SUPPLEMENTARY INFORMATION

DRESDEN NUCLEAR POWER STATION UNITS 2 AND 3

AMENDMENT NUMBER 17 FOR UNIT 2 AND AMENDMENT NUMBER 18 FOR UNIT 3

Commonwealth Edison
Company

DRESDEN II MAIN STEAM ISOLATION LEAK TESTING

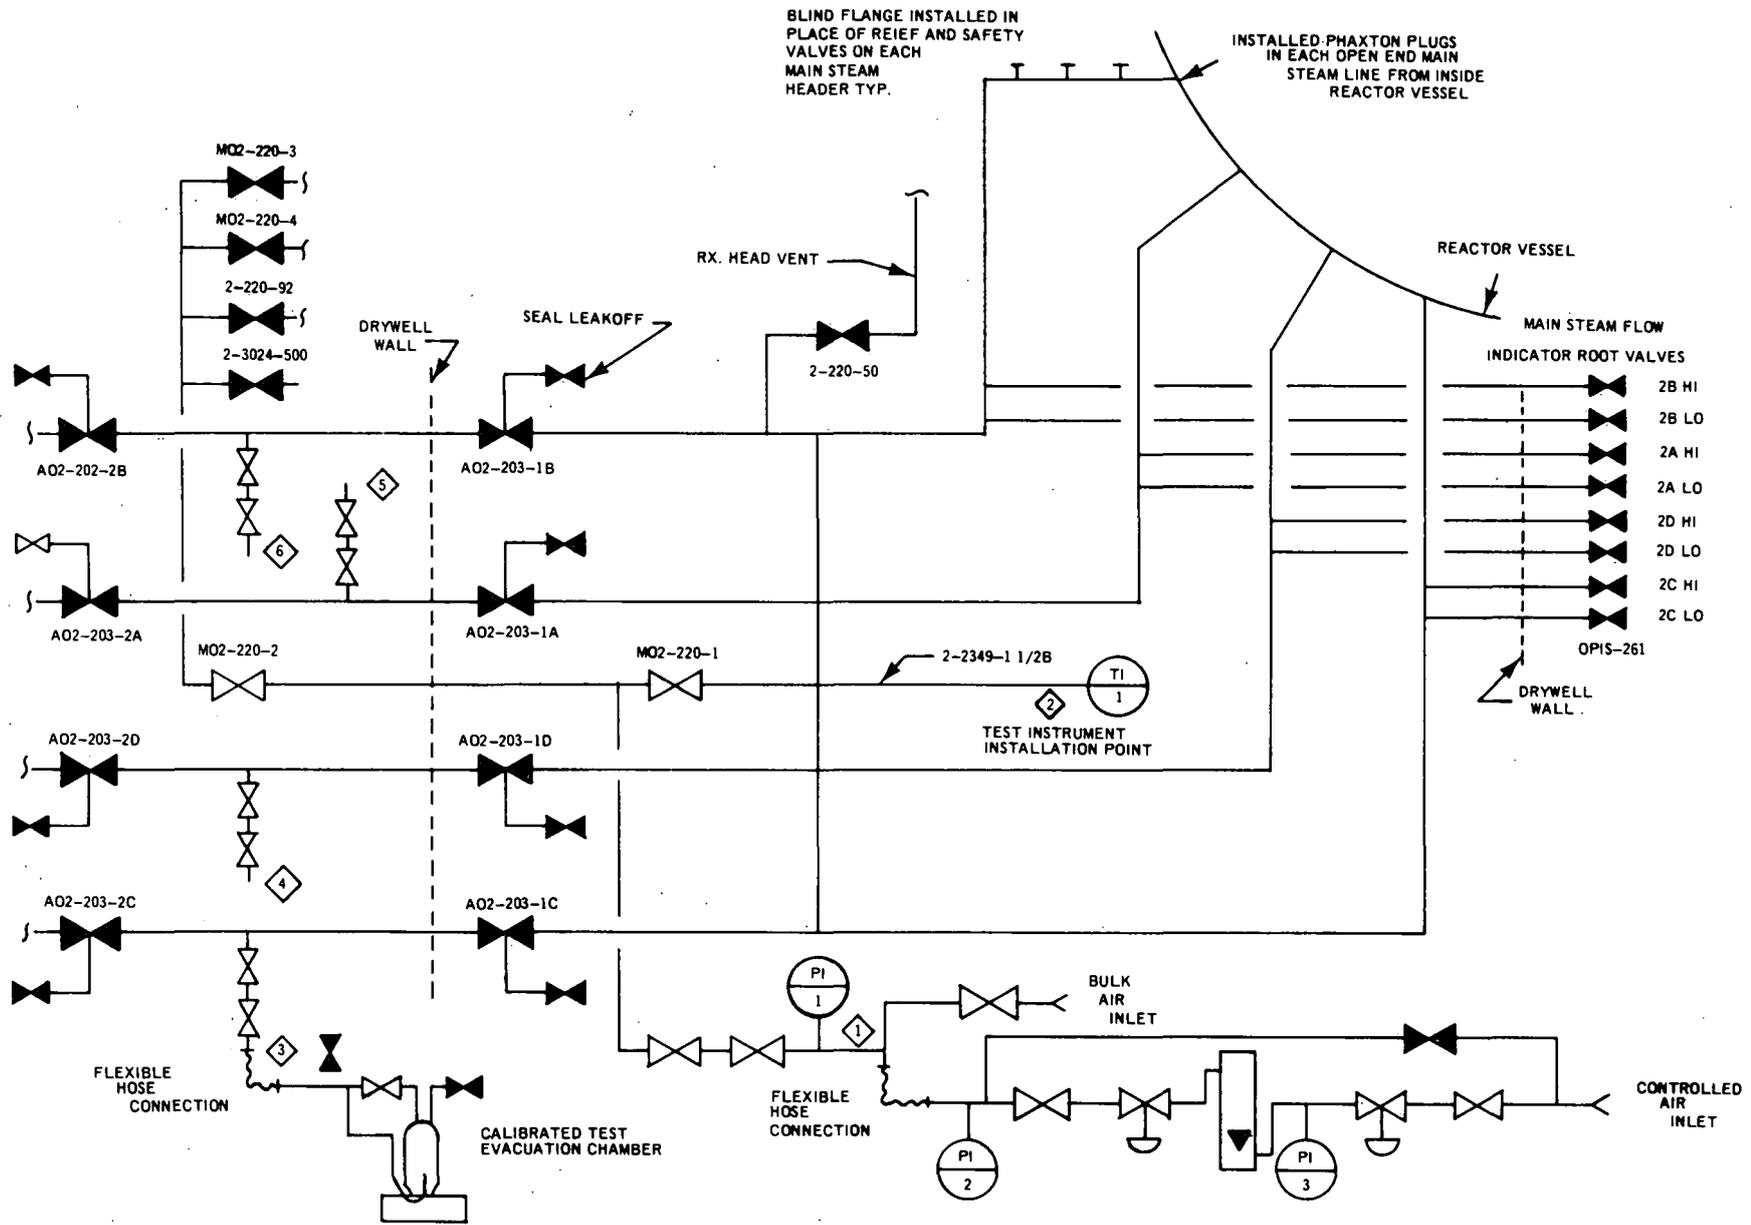
"Provide a copy of the Dresden 2 main steamline containment isolation valve design specification and the results of the construction leak tests."

During the Unit 2 construction period, leakage tests were conducted on both the inboard and outboard main steam isolation valves. The attached Figure, "Dresden II Main Steam Isolation Leak Testing," outlines the boundaries of system piping placed under test. Filtered, oil free air was used at a sustained pressure of 50 psig and containment volume was calculated at 275,481 ft³.

Following is a compilation of test results for each valve:

A0-2-203-A1	less than 1 cfh
A0-2-203-A2	less than 1 cfh
A0-2-203-B1	2 to 3 cfh
A0-2-203-B2	less than 1 cfh
A0-2-203-C1	18 to 21 cfh
A0-2-203-C2	18 to 21 cfh
A0-2-203-D1	less than 1 cfh
A0-2-203-D2	less than 1 cfh

Subsequently, valves A0-2-203-C1 and C2 were disassembled and indentations were found in the seats. After lapping the seats of each valve, they were retested. The leak rate found for these valves was 2.5 cfh.
